108-124 Forest Road, Mixed-use Development

DA Architectural Drawing List

ISSUE STATUS		
REV	DESCRIPTION	DATE
1	DA ISSUE	16/12/20
2	RESPONSE COUNCIL RFI - AMENDMENTS AS NOTED	30/07/21

TITLE	Floor Plan Level 01
ISSUE	DA
REV.	2
DRAWING NO.	DA06

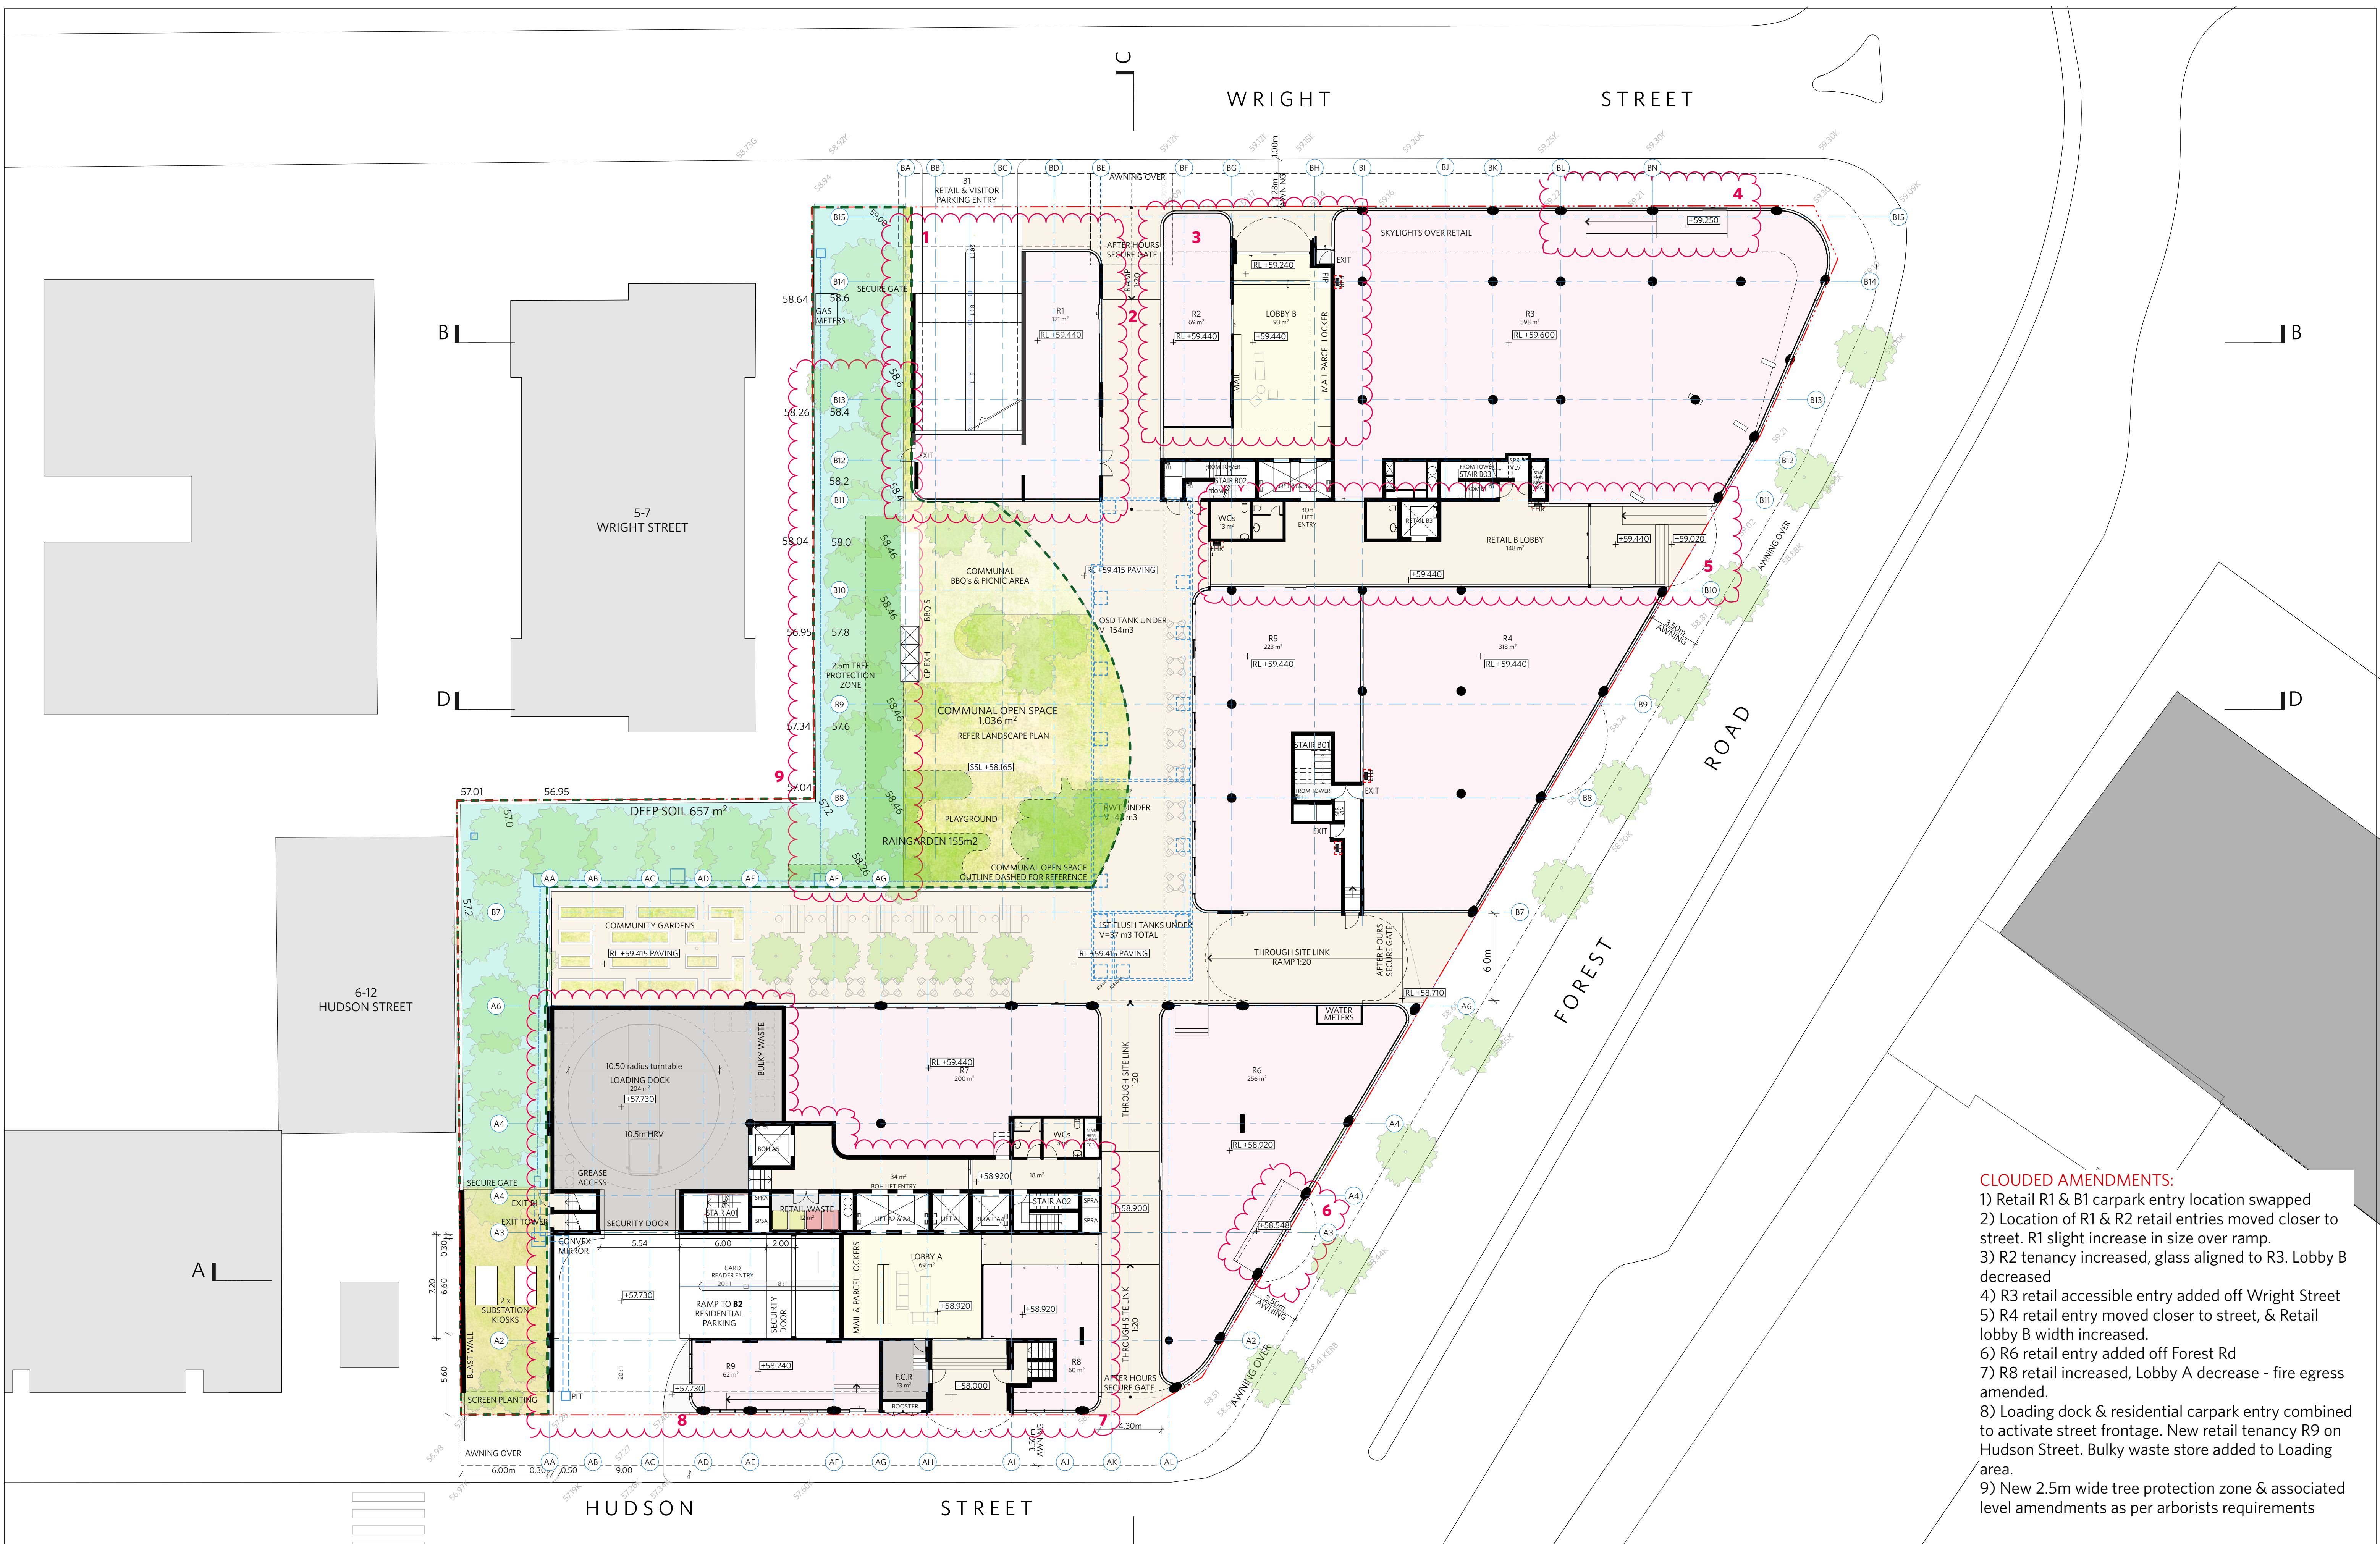
- CLOUDED AMENDMENTS:**
- 1) Retail R1 & B1 carpark entry location swapped
 - 2) Location of R1 & R2 retail entries moved closer to street. R1 slight increase in size over ramp.
 - 3) R2 tenancy increased, glass aligned to R3. Lobby B decreased
 - 4) R3 retail accessible entry added off Wright Street
 - 5) R4 retail entry moved closer to street, & Retail lobby B width increased.
 - 6) R6 retail entry added off Forest Rd
 - 7) R8 retail increased, Lobby A decrease - fire egress amended.
 - 8) Loading dock & residential carpark entry combined to activate street frontage. New retail tenancy R9 on Hudson Street. Bulky waste store added to Loading area.
 - 9) New 2.5m wide tree protection zone & associated level amendments as per arborists requirements

TITLE	Floor Plan Level 11-13	ISSUE	DA	REV.	2	DRAWING NO.	DA12
-------	------------------------	-------	----	------	---	-------------	------

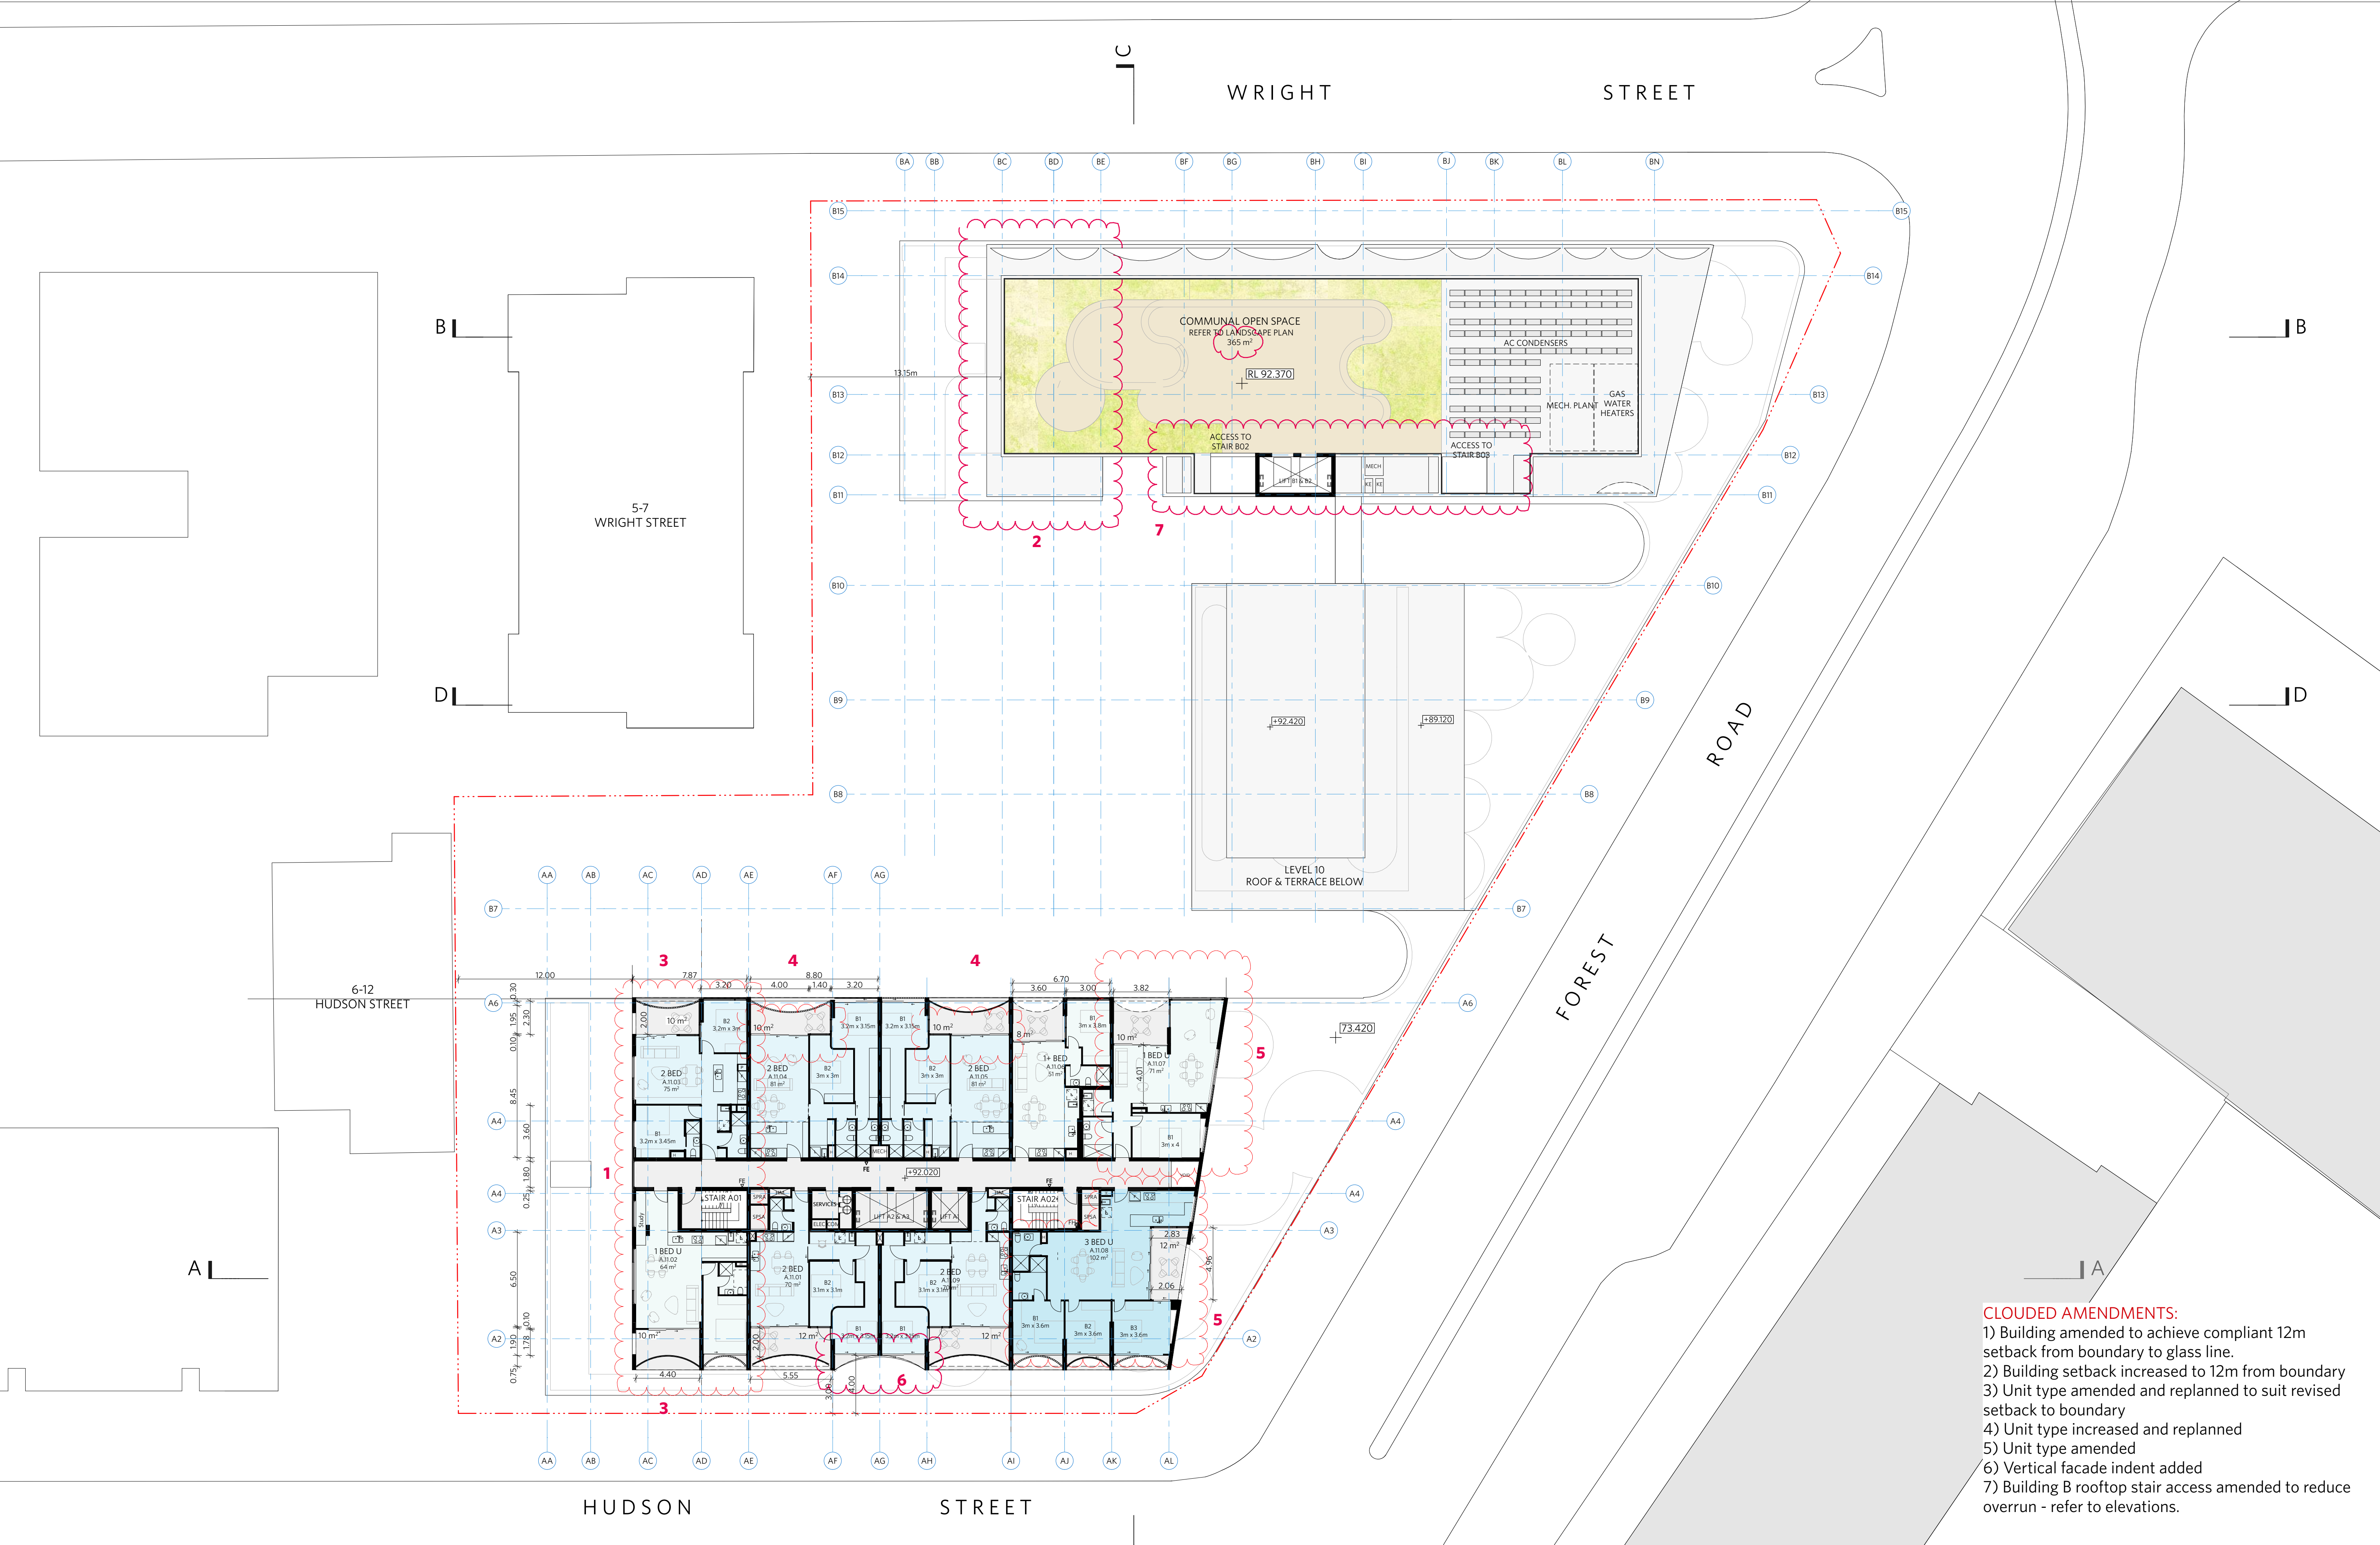
- CLOUDED AMENDMENTS:**
- 1) Building amended to achieve compliant 12m setback from boundary to glass line.
 - 2) Building setback increased to 12m from boundary
 - 3) Unit type amended and replanned to suit revised setback to boundary
 - 4) Unit type increased and replanned
 - 5) Unit type amended
 - 6) Vertical facade indent added
 - 7) Building B rooftop stair access amended to reduce overrun - refer to elevations.

TITLE		
Floor Plan Basement 02		
ISSUE	REV.	DRAWING NO.
DA	2	DA15

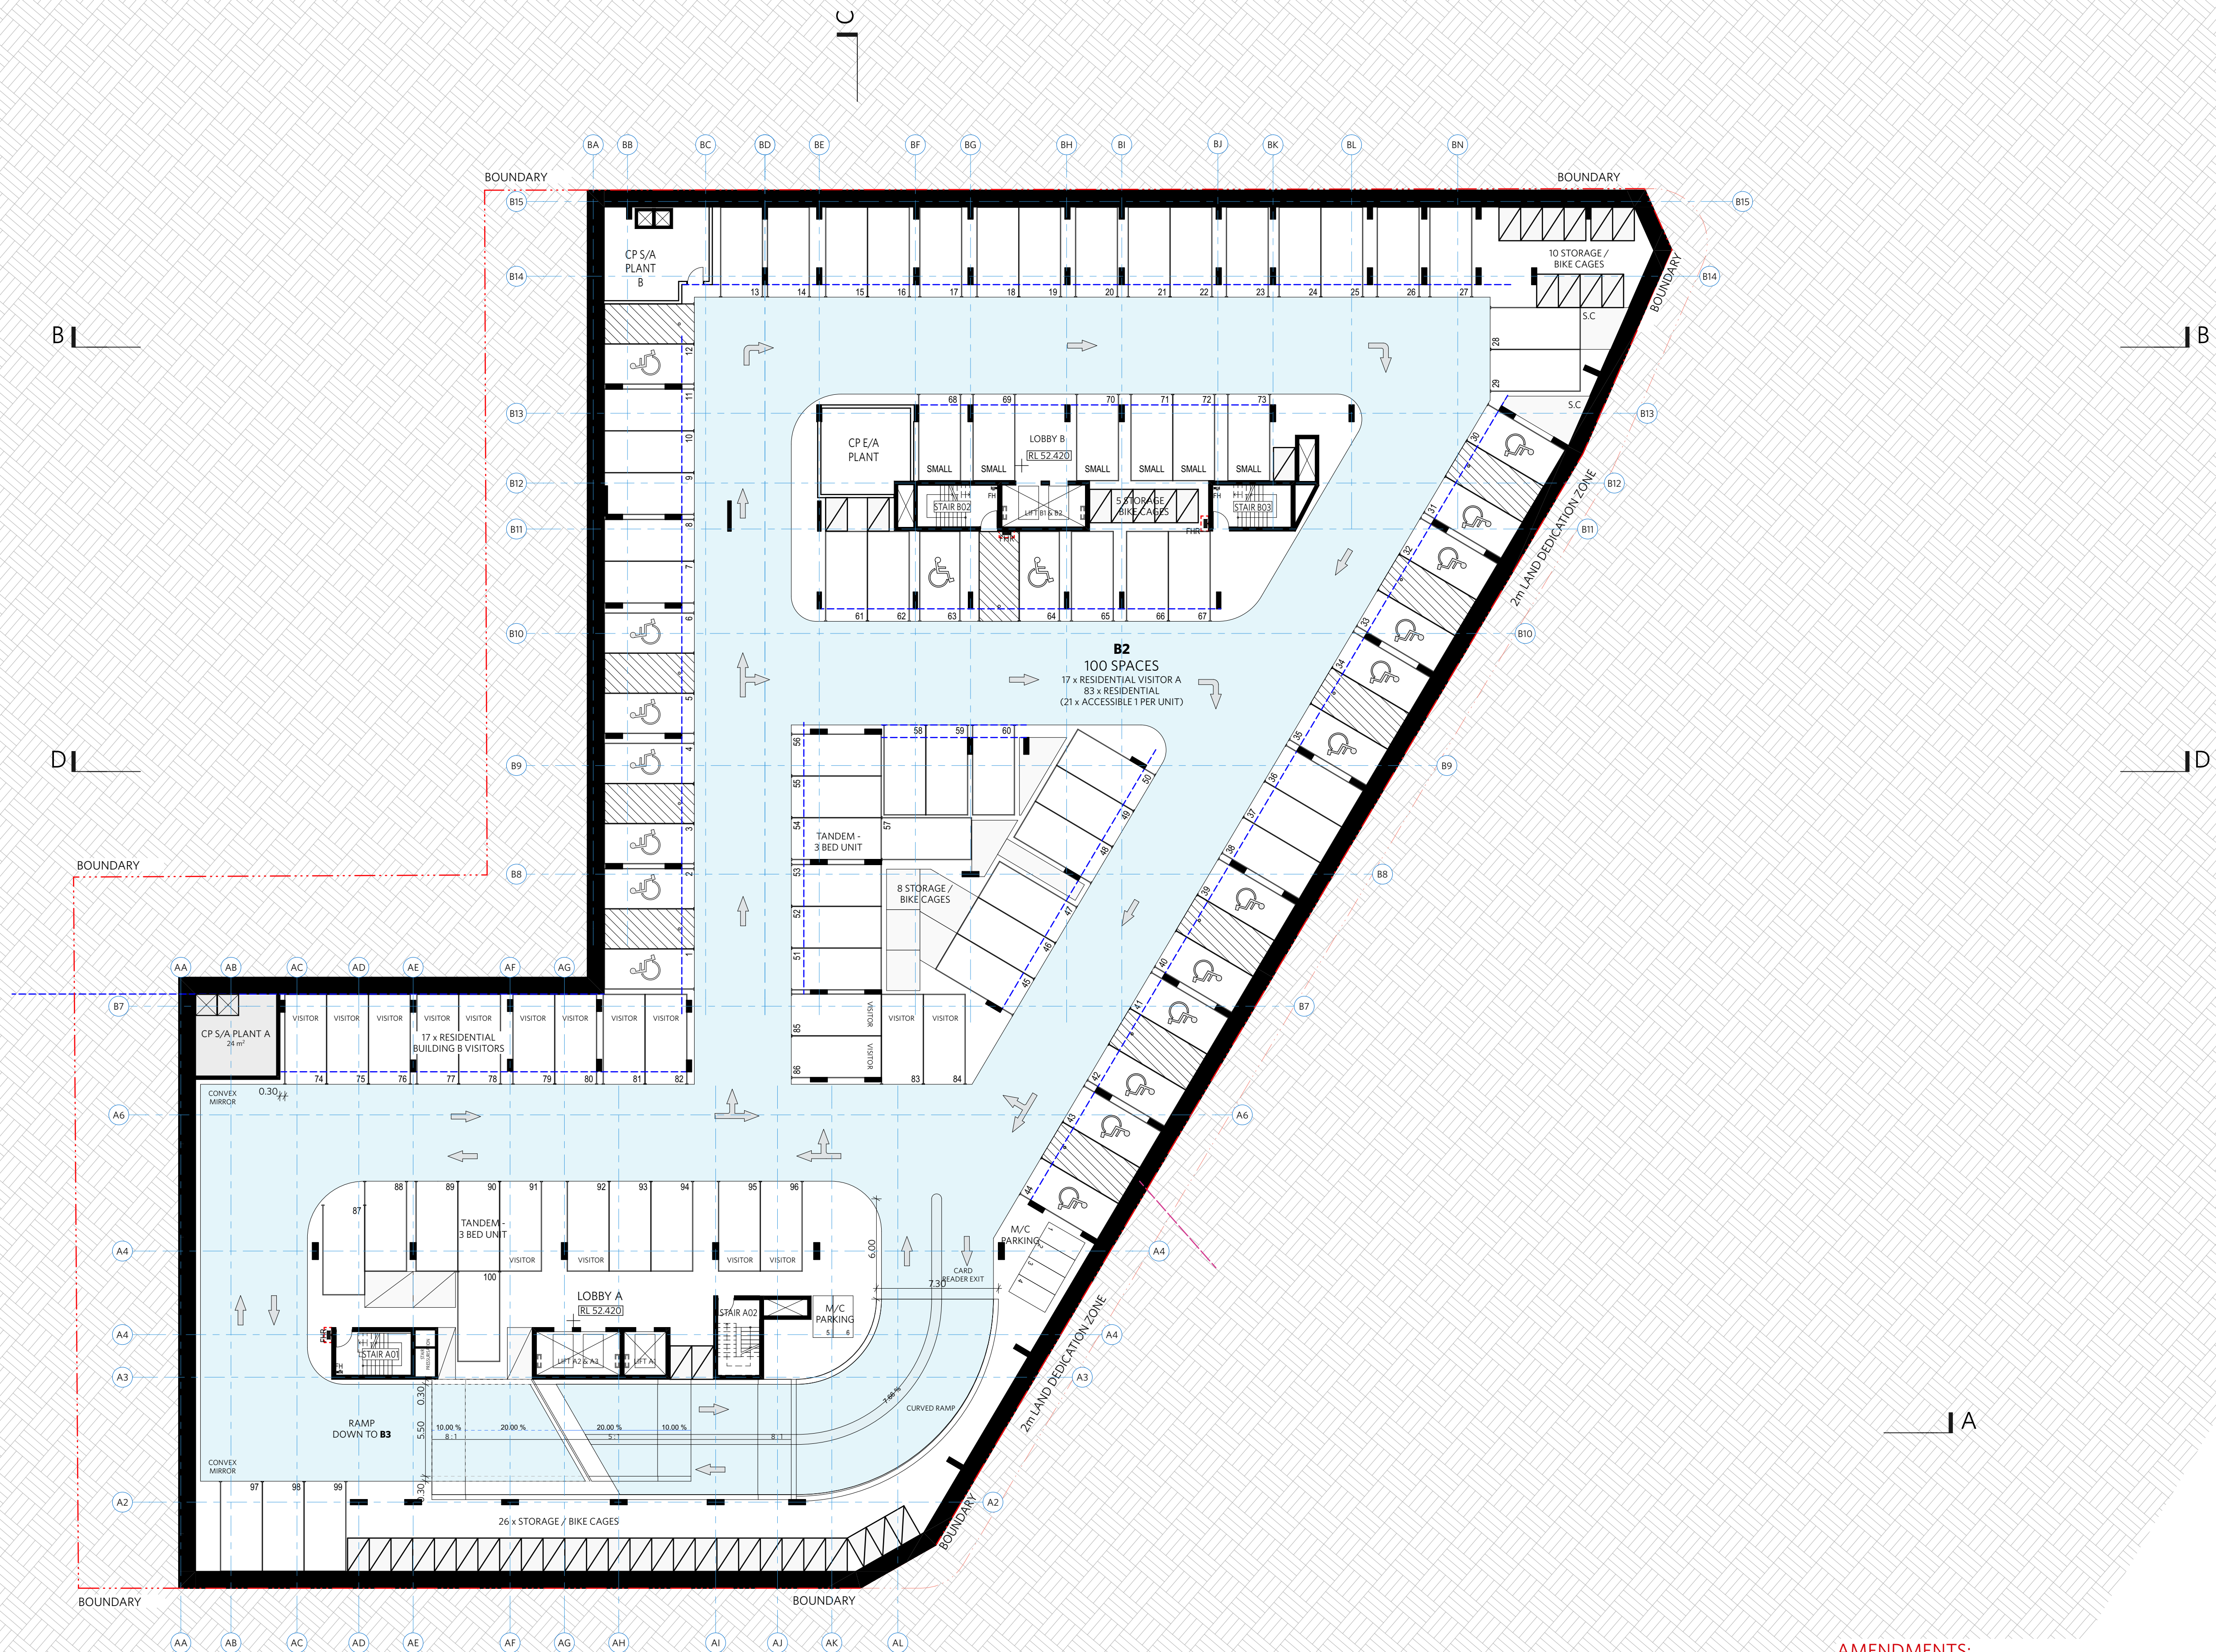
AMENDMENTS:
General Note: Basement 2 & 3 circulation route amended based on new ramp entry
